SUBJECT: Service Update for Inventory and Customer Vehicles
Product Enhancements – Interior Trim
Expires with Base Warranty

MODELS: 2013 Cadillac XTS

The Part Information section has been revised to include an additional part number for the felt. Steps 5 and 9 in the service procedure have been revised. Please discard all copies of bulletin 12250.

3257797

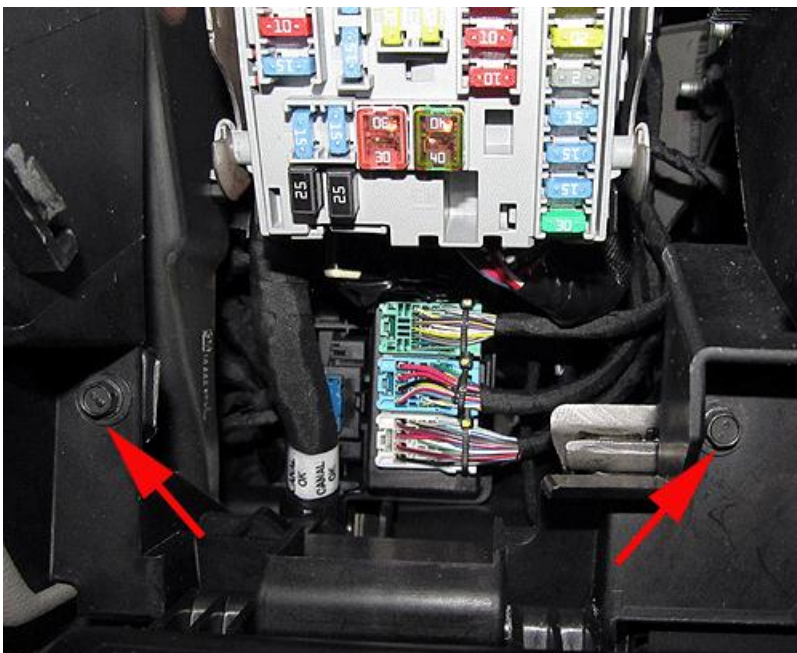
8. Add the felt to the five windshield defroster grille front plastic tabs as shown. Completely wrap each tab ensuring the felt tape covers the rib near the metal screen.
9. Install the windshield defroster grille.
10. Locate the IP storage compartment.
11. Activate the IP storage compartment release mechanism 10 times to check the operation of the IP storage compartment.
 - If the IP storage compartment does NOT make noise or ratchet while the IP storage compartment door opens or closes, proceed to step 12.
 - If the IP storage compartment does make noise or ratchet while the IP storage compartment door opens or closes, proceed to *IP Storage Compartment Door Binds or Opens Very Slowly* or *IP Storage Compartment Door Opens Very Fast and/or Creates Zip Noise* in this bulletin.

3258653

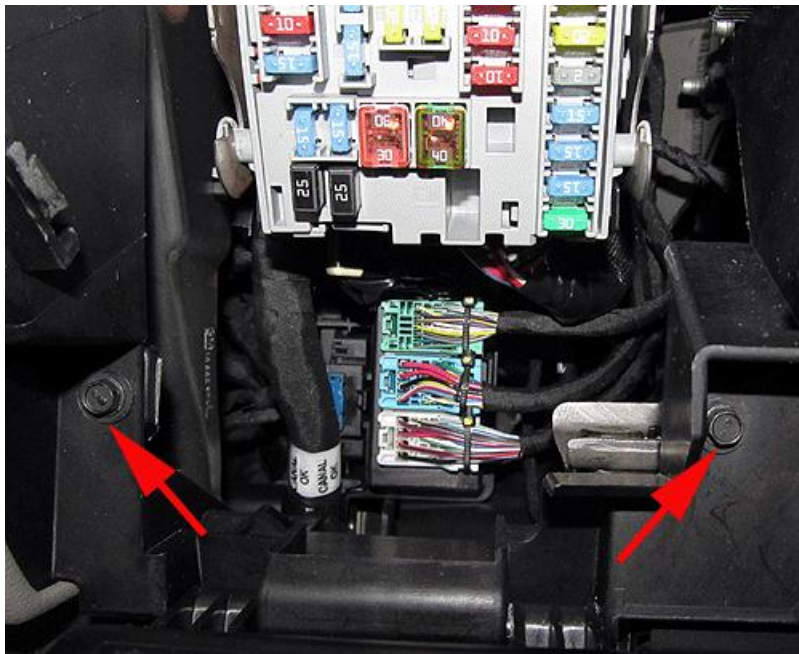
IP Storage Compartment Door Binds or Opens Very Slowly

Note: This procedure should move the rack upward slightly to release excessive engagement of rack and pinion gears.

1. Open bin door with release tabs.
2. Loosen two screws.

3. While pulling downward on left side, tighten the left screw first and then tighten the right screw.

Note: If the bin door is still slow, then repeat steps 2-3, but add an upward push at the bottom right side BEFORE tightening the right screw. Replace the IP storage compartment if the adjustment does not correct the condition. Refer to *Instrument Panel Knee Bolster Replacement* in SI.

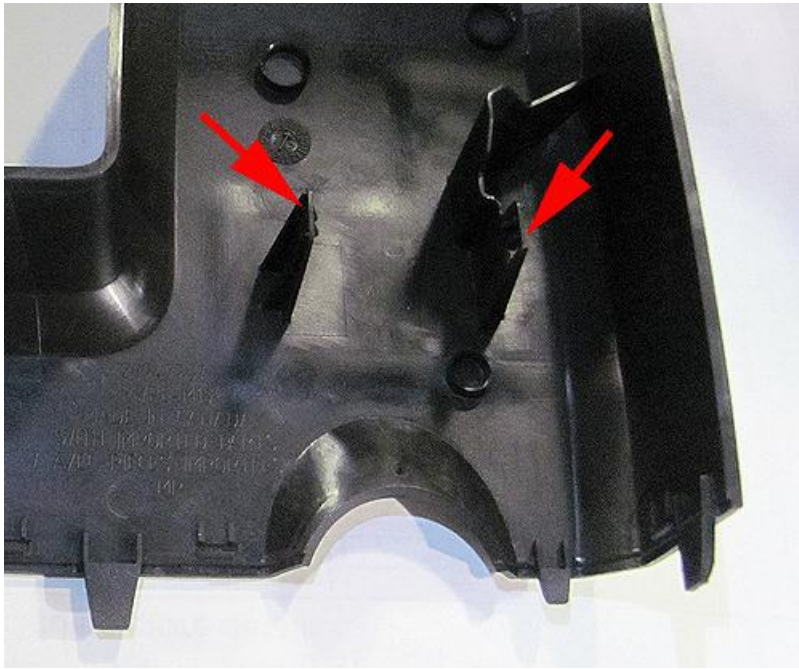
IP Storage Compartment Door Opens Very Fast and/or Creates Zip Noise

Note: This procedure should move the rack downward slightly to create more engagement of the rack and pinion gears.

1. Open bin door with release tabs.
2. Ensure pinion gear is seated.
3. Loosen two screws.
4. While pulling downward on the right side, tighten the right screw first and then the left screw.

Note: Replace the IP storage compartment if the adjustment does not correct the condition. Refer to *Instrument Panel Knee Bolster Replacement* in SI.
